REQUEST FOR COUNCIL ACTION

AGENDA SECTION: PUBLIC HEARINGS	ORIGINATING DEPT: PLANNING	ITEM NO. E-2
ITEM DESCRIPTION: Type III, Phase II Amendment #03-01 to the Final Plan which covers the Apache Mall Shopping Center, to allow for the construction of a freestanding restaurant in the location of demolished Montgomery Wards Auto Store by Romano's Macaroni Grill. The proposal is to construct a 6,820 square foot building. The property is located north of 16 th Street SW, west of Apache Drive SW and east of Highway 52.		PREPARED BY: Mitzi A. Baker, Senior Planner

RE: Type III, Phase II Amendment #03-01 to the Final Plan which covers the Apache Mall Shopping Center, to allow for the construction of a freestanding restaurant in the location of demolished Montgomery Wards Auto Store by Romano's Macaroni Grill. The proposal is to construct a 6,820 square foot building. The property is located north of 16th Street SW, west of Apache Drive SW and east of Highway 52.

SITE PLAN

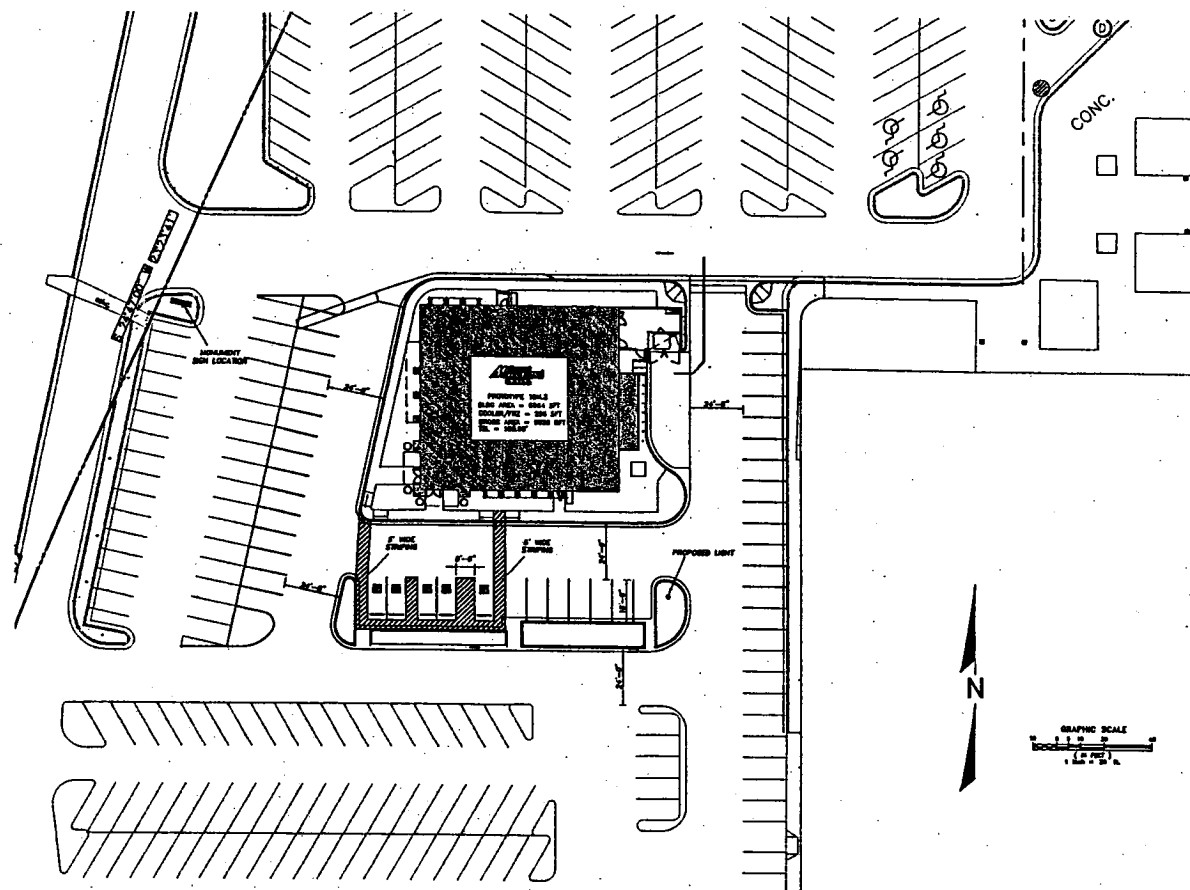
Parking lot modifications adjacent to the building are proposed with this project. Dimensions shown on the Plan are not consistent with the requirements of the Rochester Zoning Ordinance and Land Development Manual. Parking stall length

shown on the Plan should be at 17', not 18' as labeled, and drive isle widths should be at 25', not 24' as labeled.

1. ***Parking lot modifications adjacent to the building are proposed with this project. Dimensions shown on the Plan are not consistent with the requirements of the Rochester Zoning Ordinance and Land Development Manual. Parking stall length shown on the Plan should be at 17', not 18' as labeled, and drive isle widths should be at 25', not 24' as labeled.***
2. ***If the extension of public watermain, and/or the addition of hydrant(s) is required for this project, the execution of a City-Owner Contract, and dedication of an applicable public utility easement, will be required prior to construction.***
3. ***Grading Plan approval is required, prior to construction.***

UTILITY PLAN

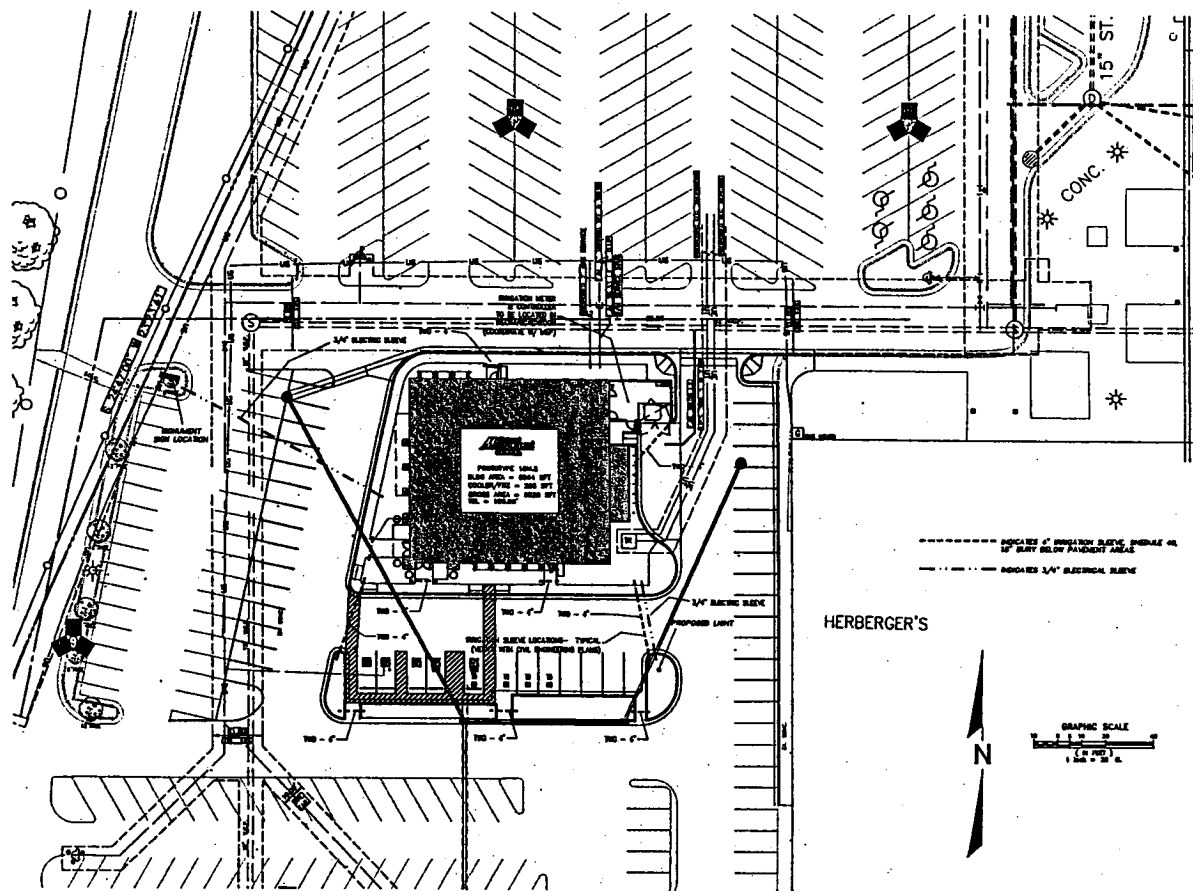
1. If the extension of public watermain, and/or the addition of hydrant(s) is required for this project, the execution of a City-Owner Contract, and dedication of an applicable public utility easement, will be required prior to construction.
2. Grading Plan approval is required.
